BROWNS FERRY NUCLEAR PLANT (BFN) – UNITS 1, 2, AND 3 – TECHNICAL SPECIFICATIONS (TS) CHANGES TS-418 AND TS-431 – EXTENDED POWER UPRATE (EPU) – RESPONSE TO ROUND 23 REQUEST FOR ADDITIONAL INFORMATION (RAI) REGARDING STEAM DRYER SIGNAL PROCESSING (TAC NOS. MD5262, MD5263, AND MD5264)

**TENNESSEE VALLEY AUTHORITY
BROWNS FERRY NUCLEAR PLANT (BFN)
UNITS 1, 2, AND 3**

**TECHNICAL SPECIFICATIONS (TS) CHANGES TS-431 AND TS-418
EXTENDED POWER UPRATE (EPU)**

**RESPONSE TO ROUND 23 REQUEST FOR ADDITIONAL INFORMATION (RAI)
REGARDING STEAM DRYER SIGNAL PROCESSING**

Figure EMCB.203-1.9a: Autospectra of EIC removed data for BFN1 main steam line A: upper strain gage location (top), lower strain gage location (bottom), for CLTP conditions (black) and LF conditions (blue).

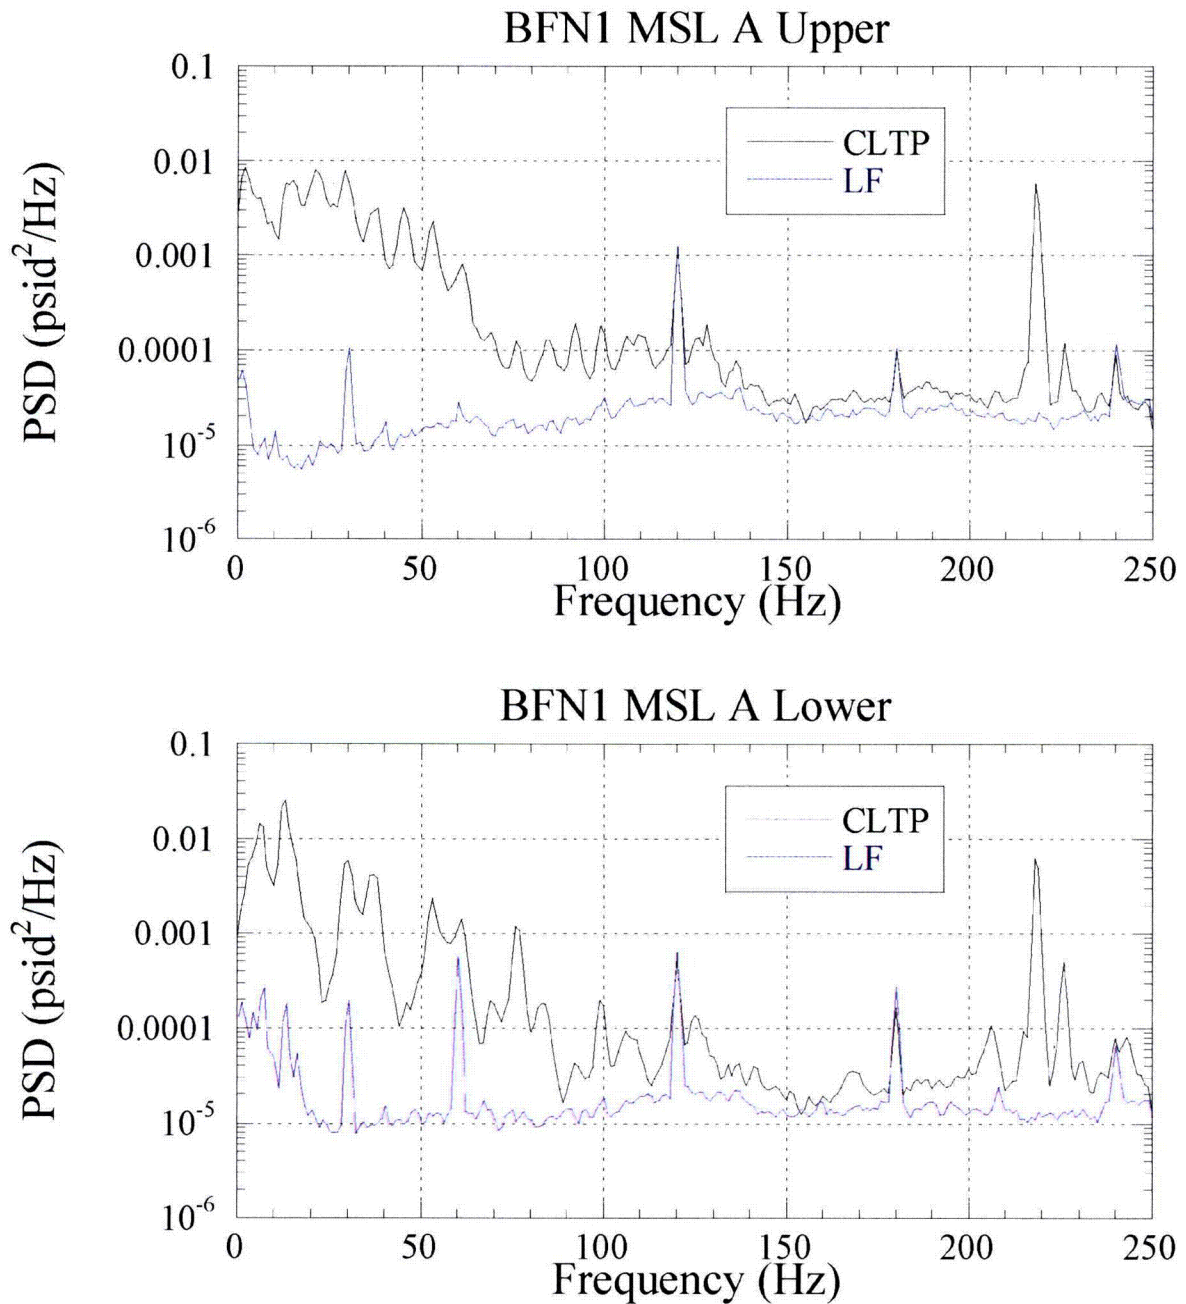
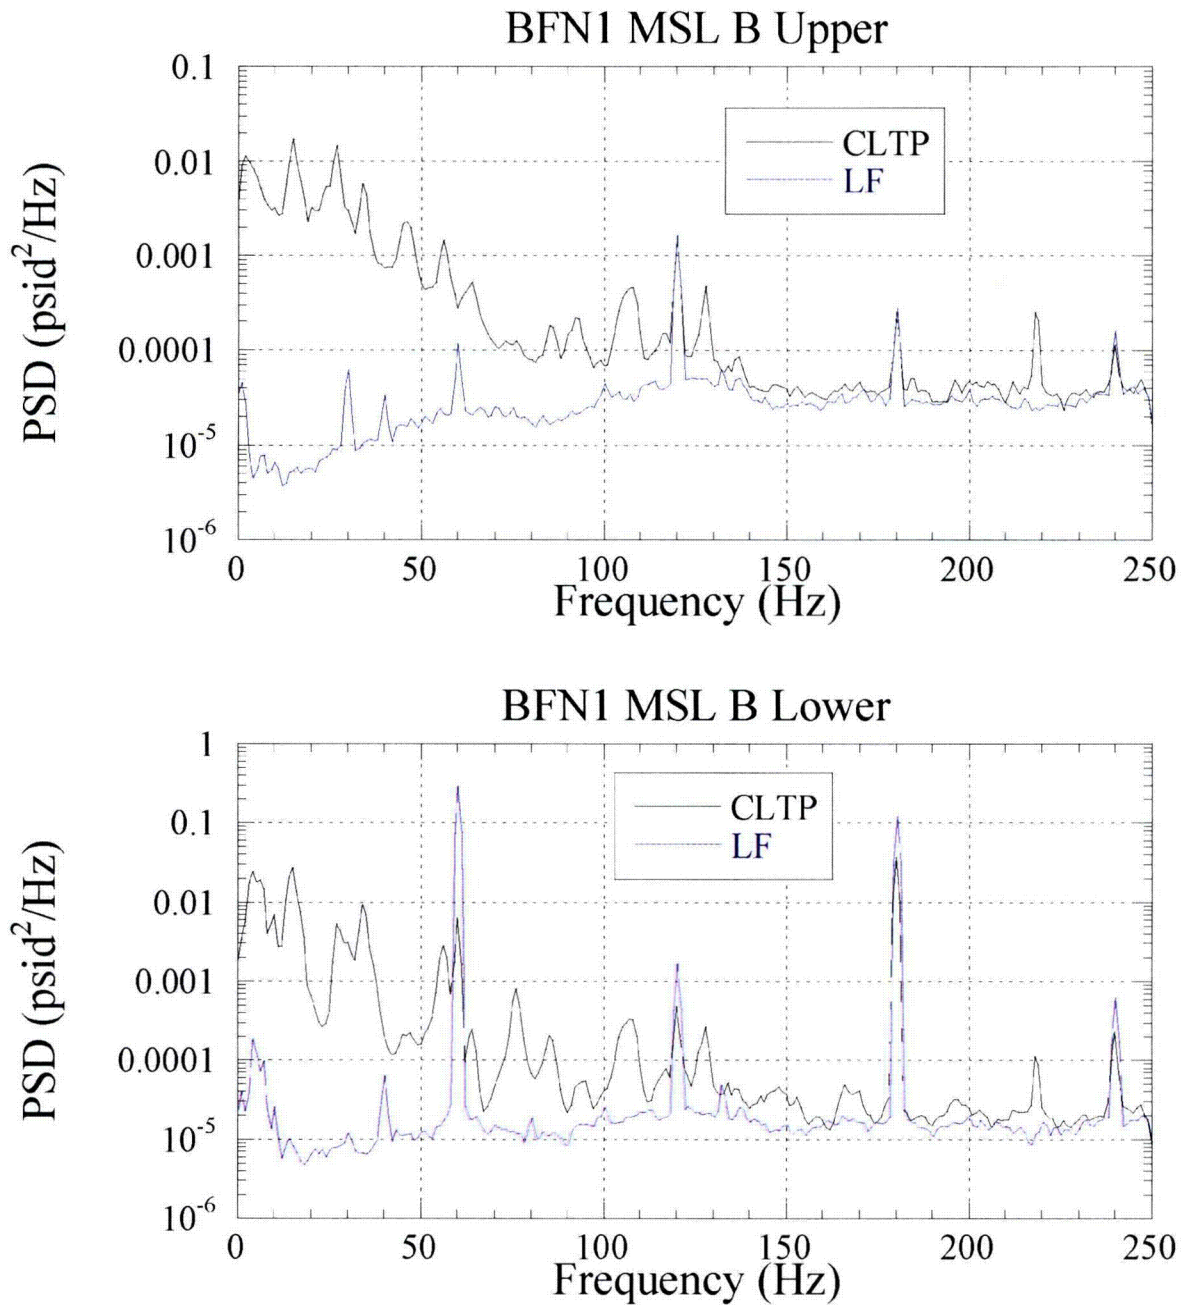
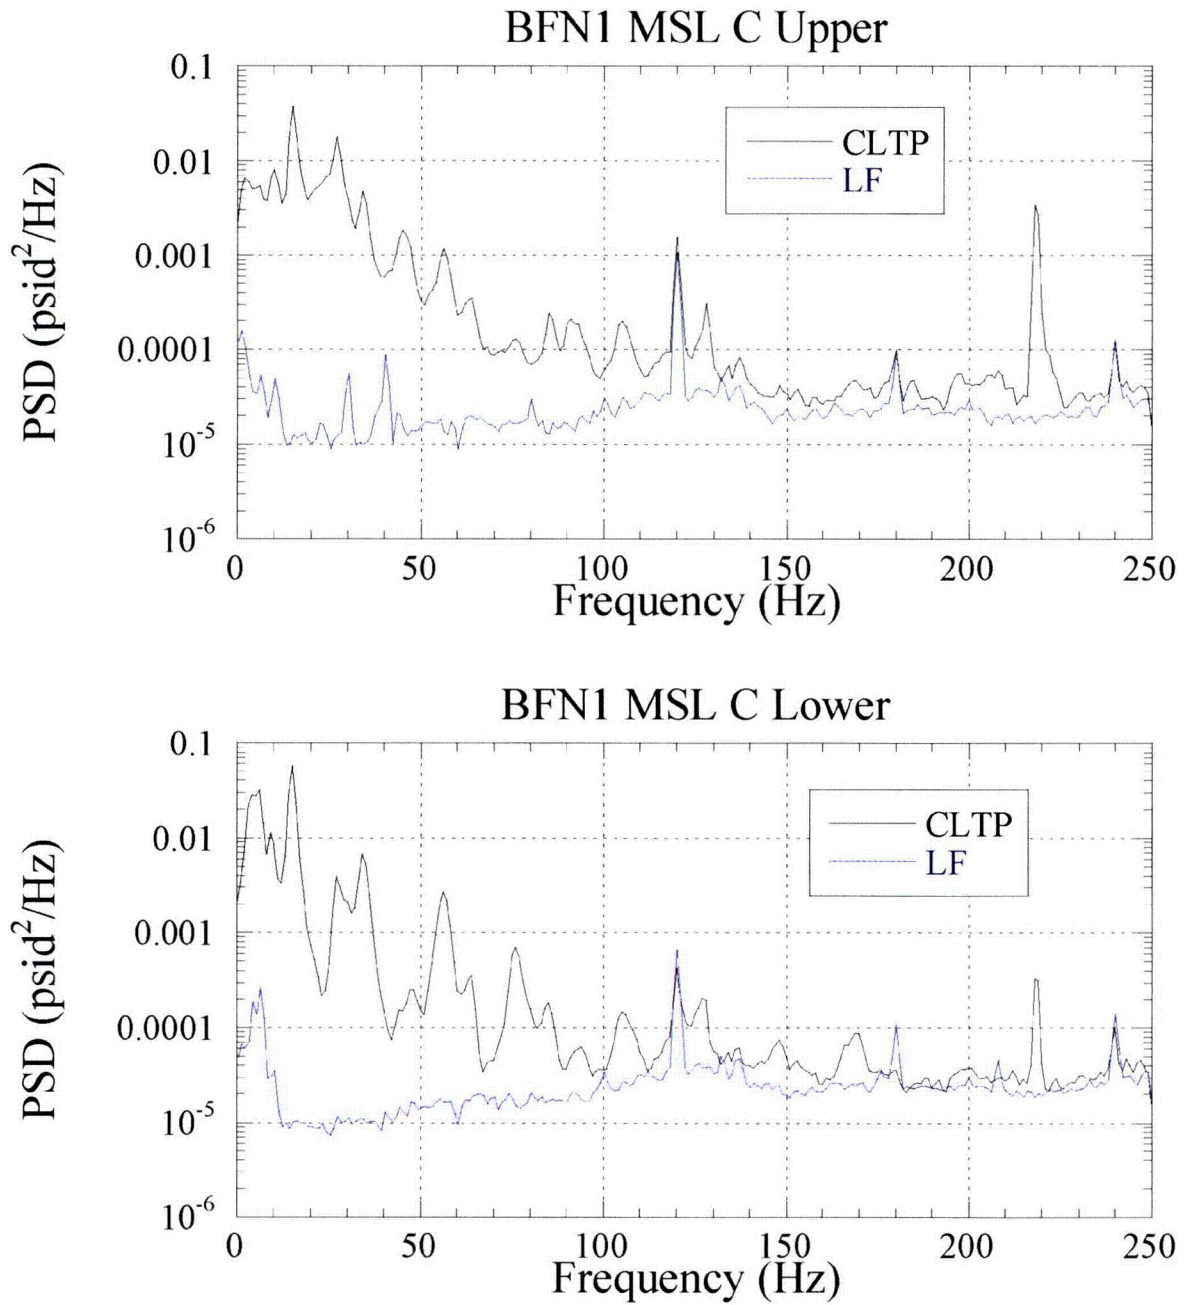
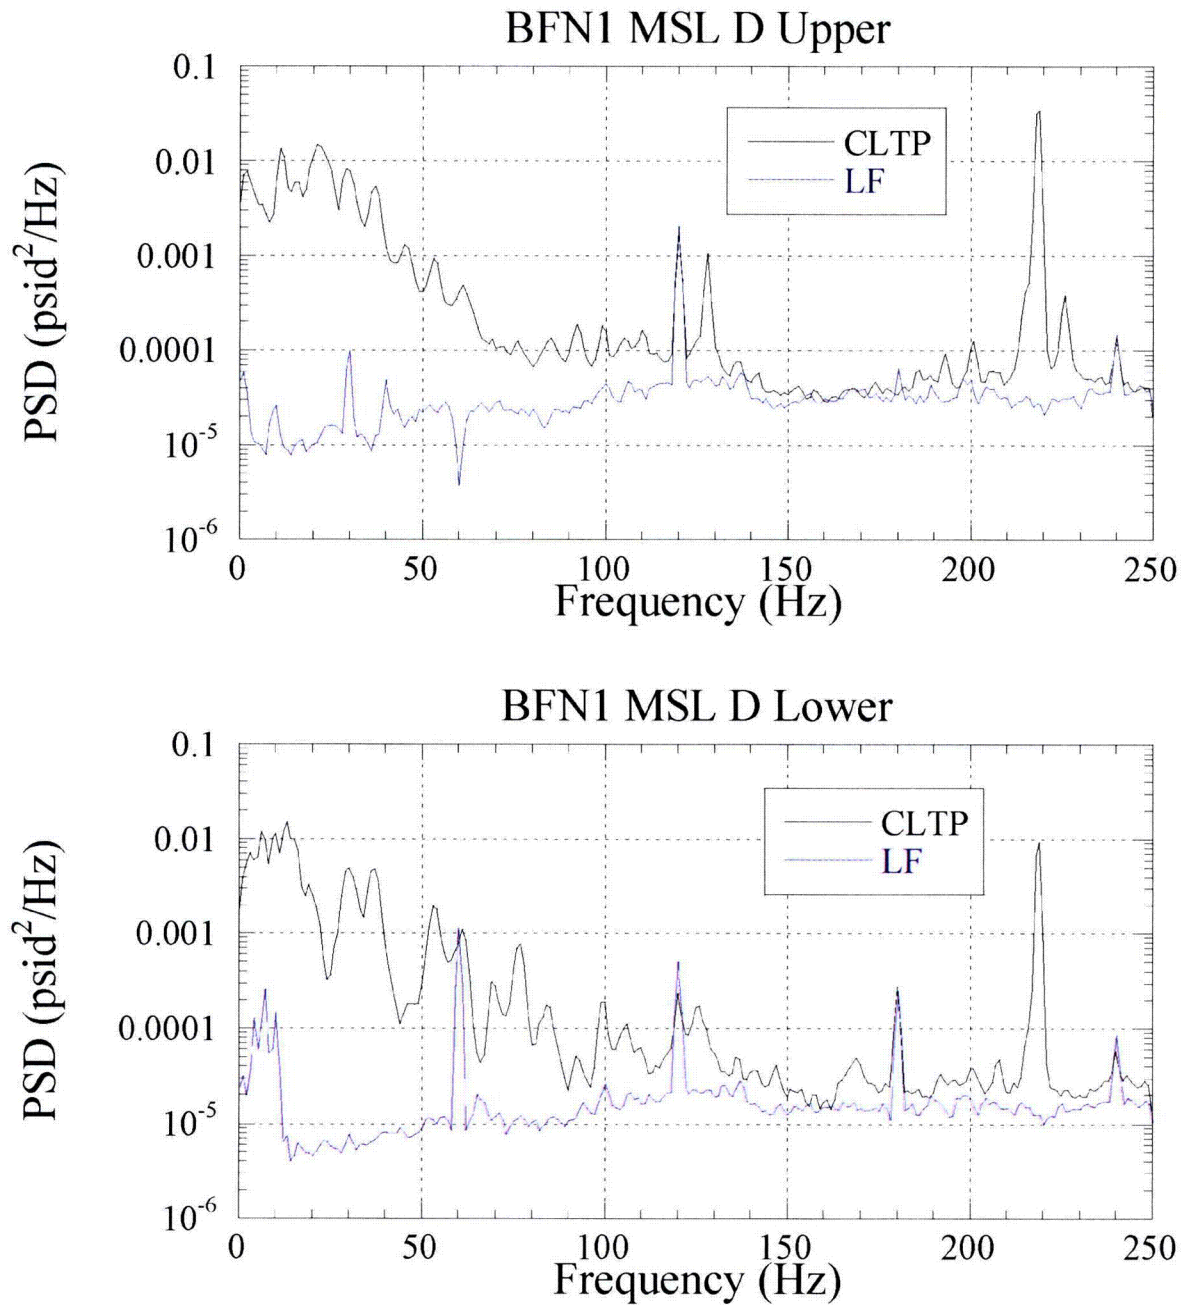
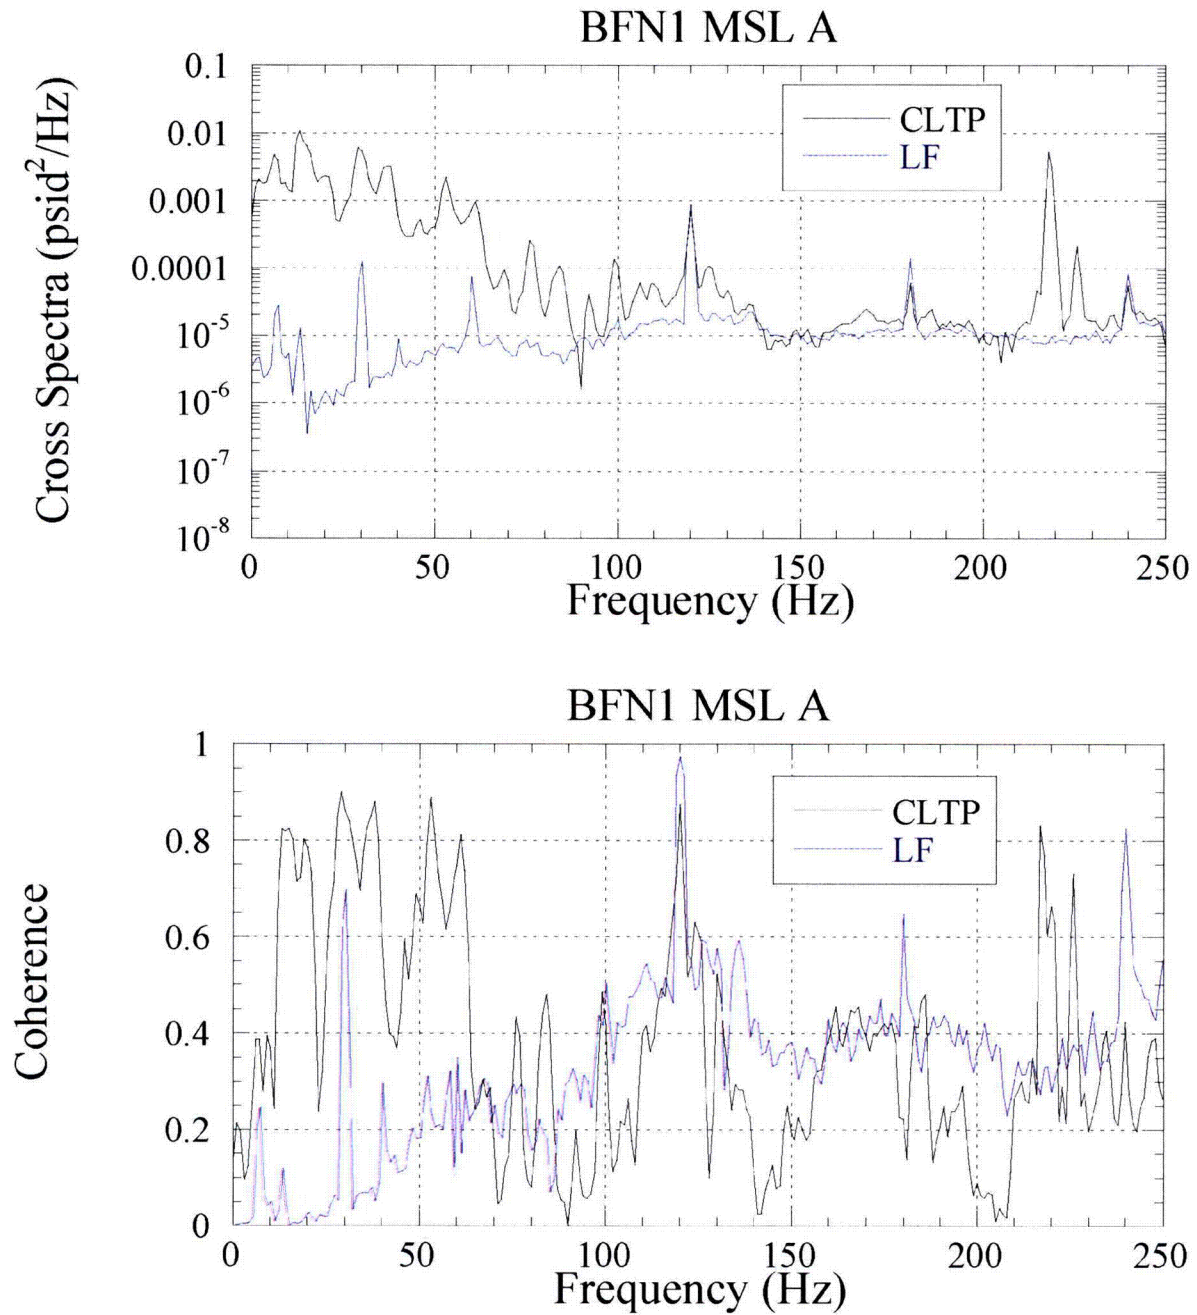
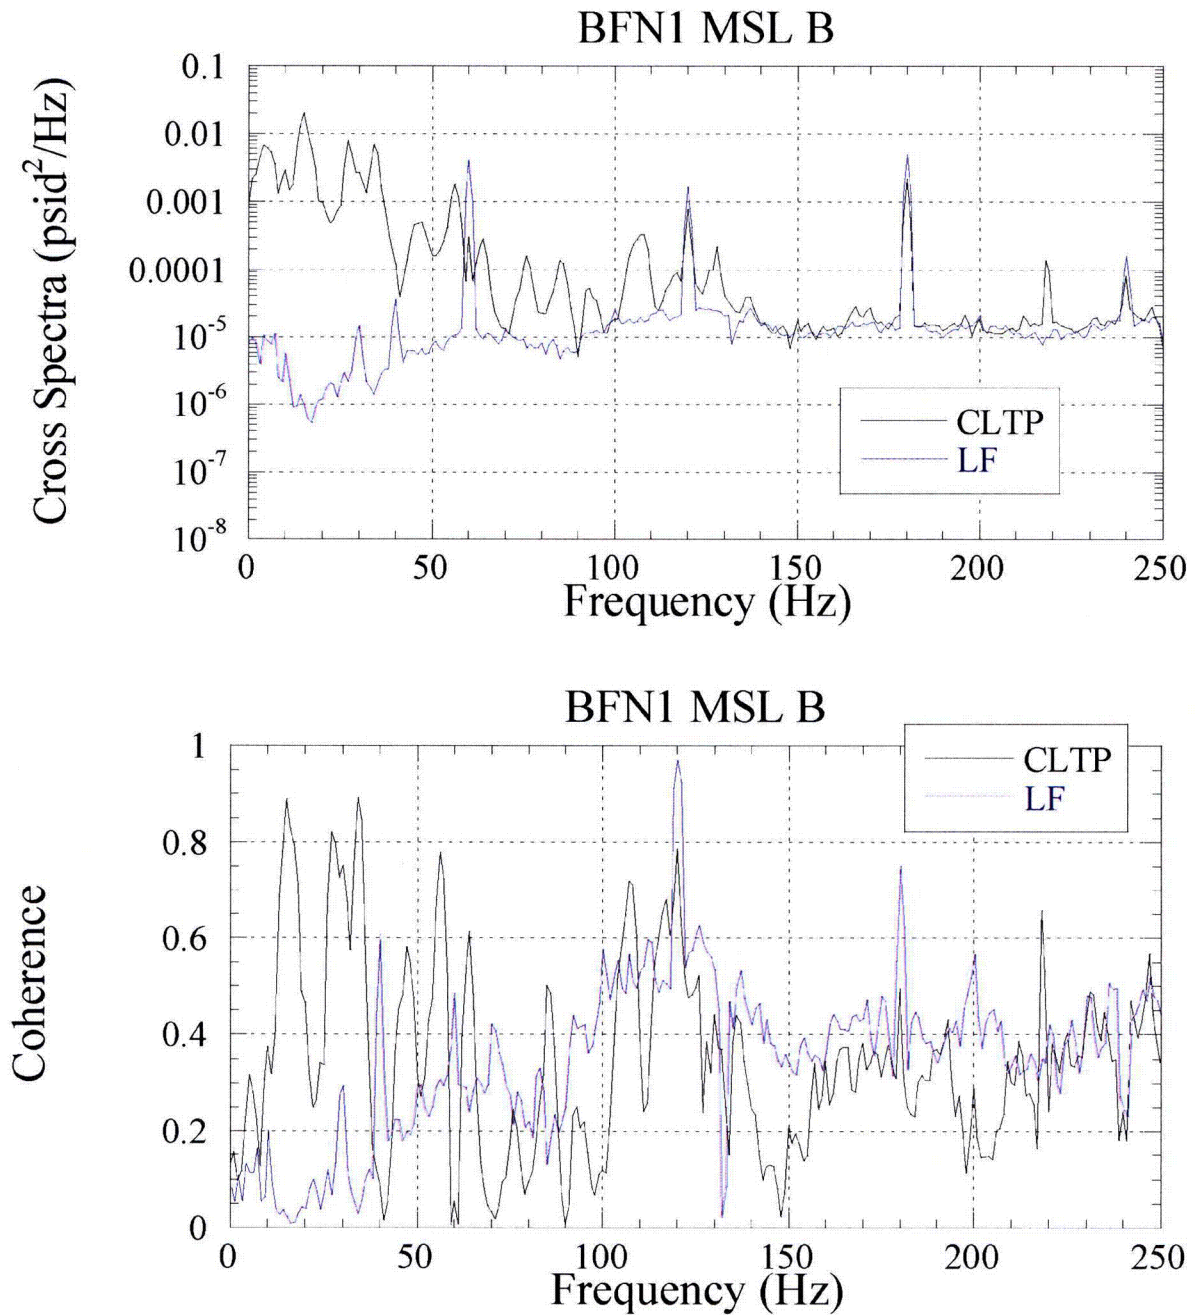
In response to EMCB.200/157., TVA presents detailed discussion of signal conditioning in six steps. Provide plots of strain gage signals (autospectra, cross spectra, coherence, and phase) and computed [[]] throughout the procedure described in their RAI response (prior to step 1, after step 1, after step 2, after step 4 and after step 6), for current license thermal power (CLTP) and Low Flow (LF) signals, for Units 1 and 2.

After Step 1: remove EIC
